DECISION OF THE PLANNING ADMINISTRATOR

**CLASS 3 SITE PLAN REVIEW / CLASS 2 DRIVEWAY APPROACH PERMIT
CASE NO.: SPR-DAP22-46**

SUMMARY: Development of gas station and retail building with associated modifications on two properties.

New Gas Station and C-Store

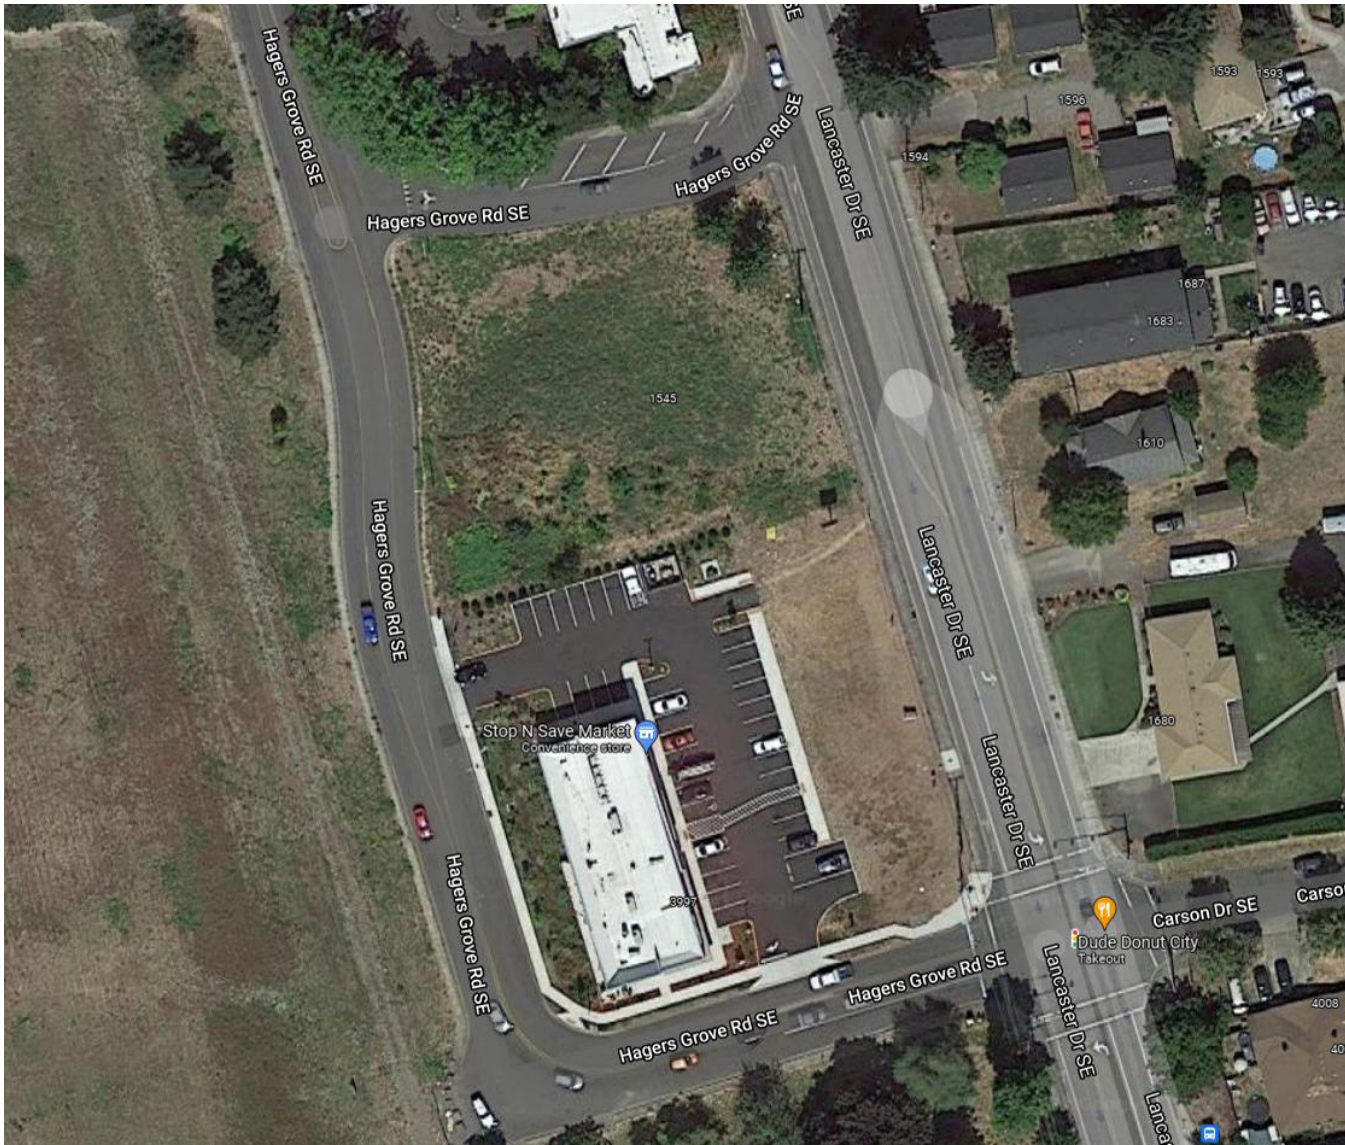
Finding: The proposed development does not change the setbacks for the existing building abutting the south and west property lines; the new accessory structure for the trash enclosure on the south parcel is setback ten feet from the east property line and does not abut the property line to the south. The proposed building on the north parcel is setback at least five feet from the west property line and well over five feet from the north property line. The new vehicle use area on the north parcel and all changes on the south parcel are setback at least ten feet, meeting or exceeding the vehicle use area setbacks. The proposal is in compliance with all applicable setback requirements of the CR zone and SRC Chapter 806.

Finding: The proposed plans do not indicate the pad area surrounding the trash enclosures, and construction details of the trash enclosure were not submitted to verify conformance with all standards. To ensure compliance with all of the following standards, the following condition applies:

Finding: The applicant's site plan indicates four proposed bike parking spaces on the east side of the north building and four existing bike parking spaces on the east side of the south building, both of which are within a convenient distance of their respective building entrances. The applicant has provided details that indicate the bicycle racks meet the required dimensions and design standards. Further conformance will be verified at the time of building permit review.

There is an existing slope easement on the subject property that was acquired by the City of Salem for the realignment of Hagers Grove Road SE. The applicant's site plan shows one of the new buildings located within the easement area. New structures are not permitted within City of Salem easements. Prior to issuance of a building permit for the new structure, all, or a portion of, the easement shall be quitclaimed.

- Condition 7:** All or a portion of the slope easement on the subject property that conflicts with the proposed building shall be quitclaimed prior to building permit issuance.

Condition 1: At the time of building permit review, the applicant shall submit updated plans which do not include the oil-change facility building as part of development.

Condition 2: At the time of building permit review, the applicant shall provide construction details for the trash enclosure indicating conformance with SRC Chapter 800.
